2. PROPOSED MINOR AMENDMENTS

2.4 MINOR ELEVATION AMENDMENTS

Consented South-East Elevation

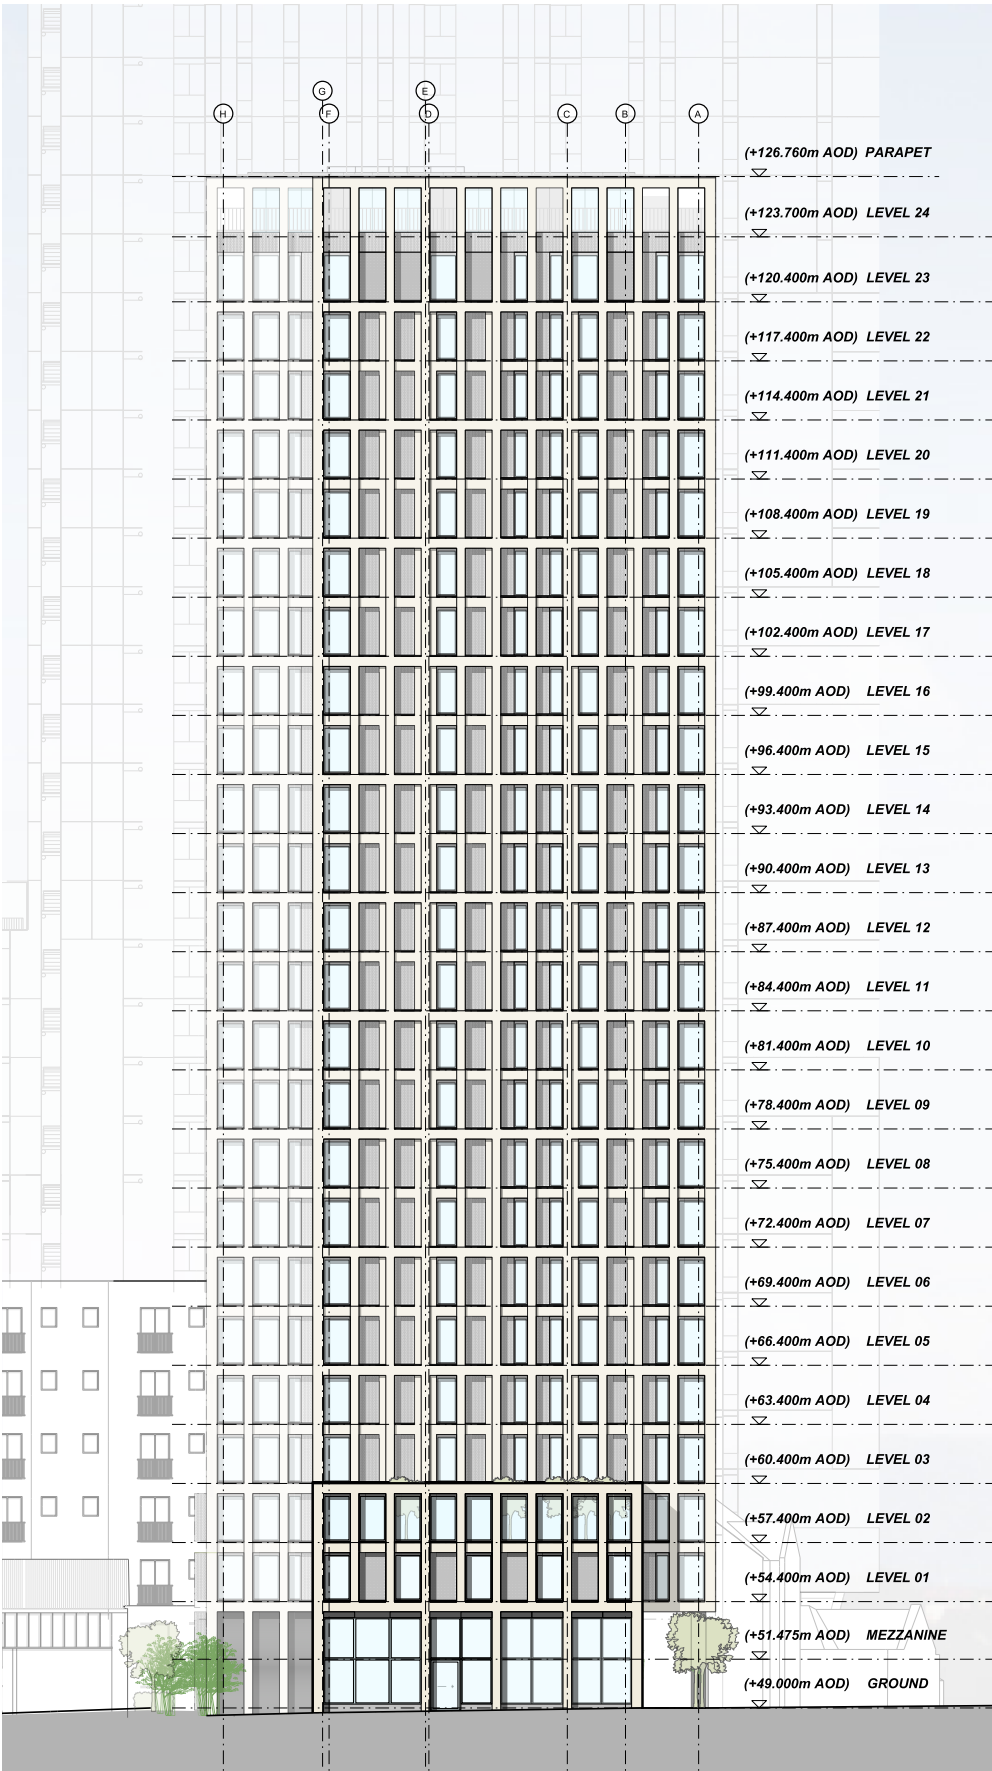
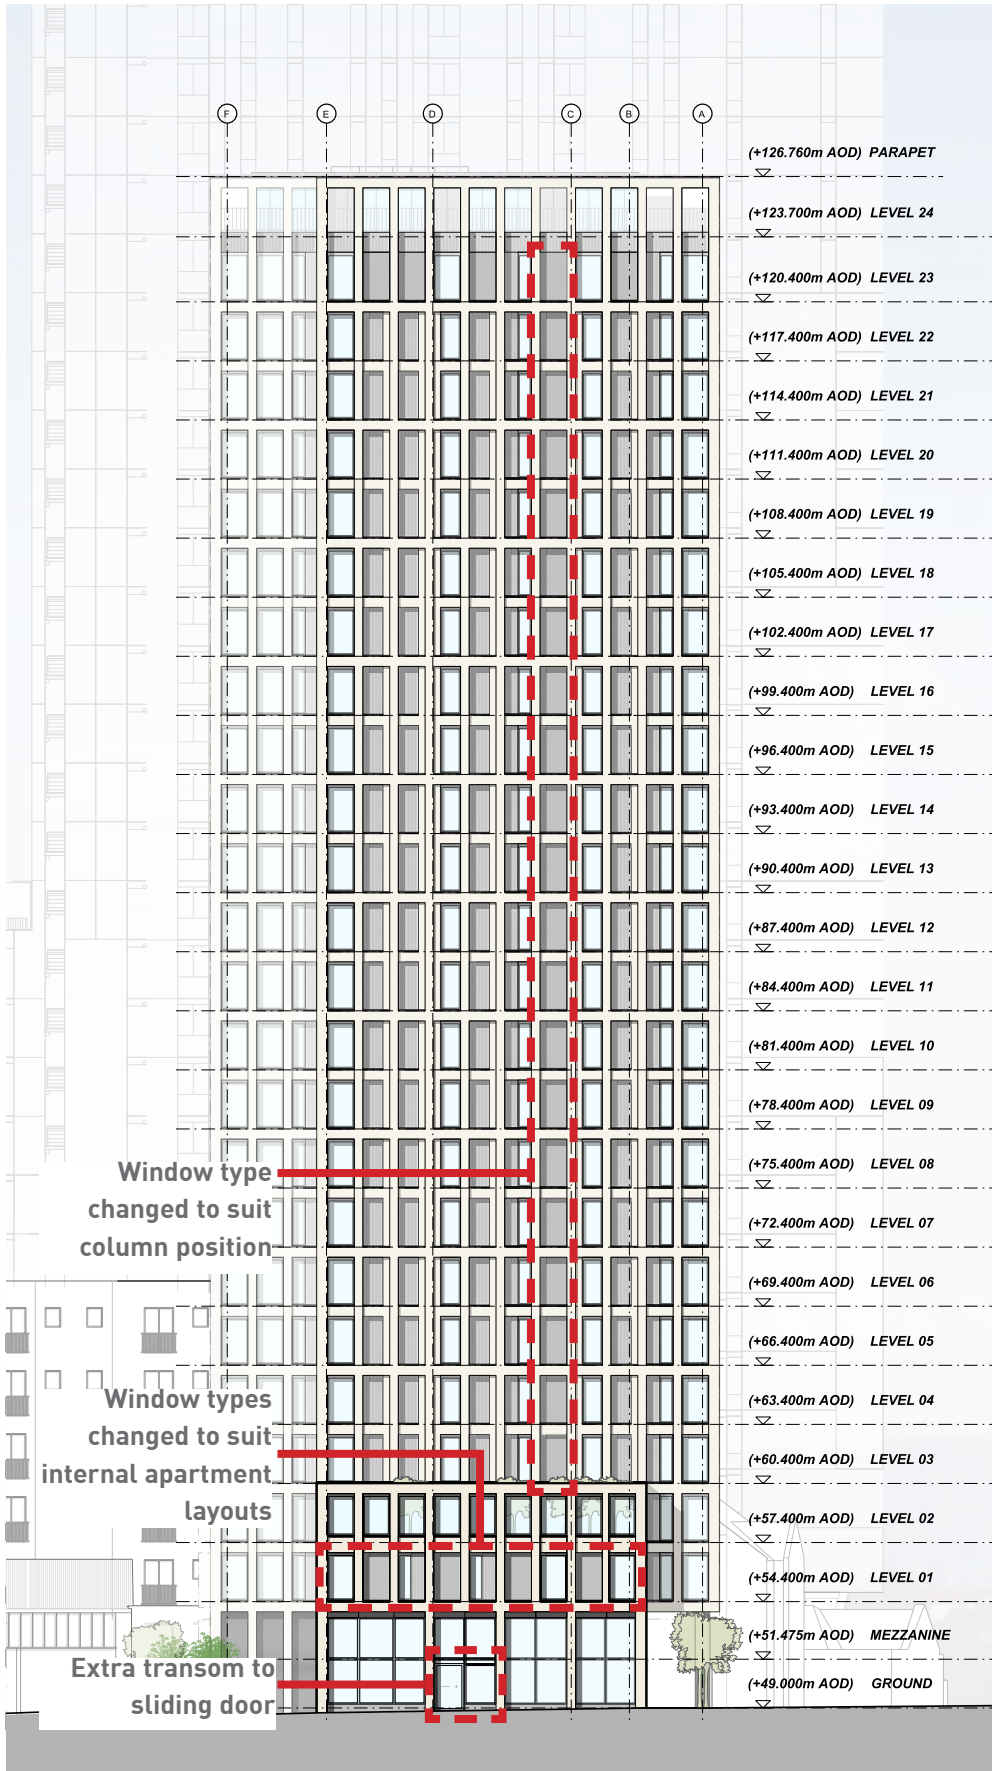
Level 01 of the proposed South West and South East elevations have minor window type amendments as a result of further detailed coordination of the internal layout. The window types have changed from clear fixed glazing to rapid vents to suit the additional two apartments that were part of the previous amendments application.

Level 03 to 23 of the proposed South East elevation have minor window type amendments as a result of further detailed coordination with structure. An extra column was required therefore the window type changed from clear fixed glazing to a solid metal infill panel behind perforated metal screen.

Following technical design development of the curtain wall system, the proposed elevations indicate additional horizontal transom details to the ground floor sliding doors, which are required to provide additional structural support.
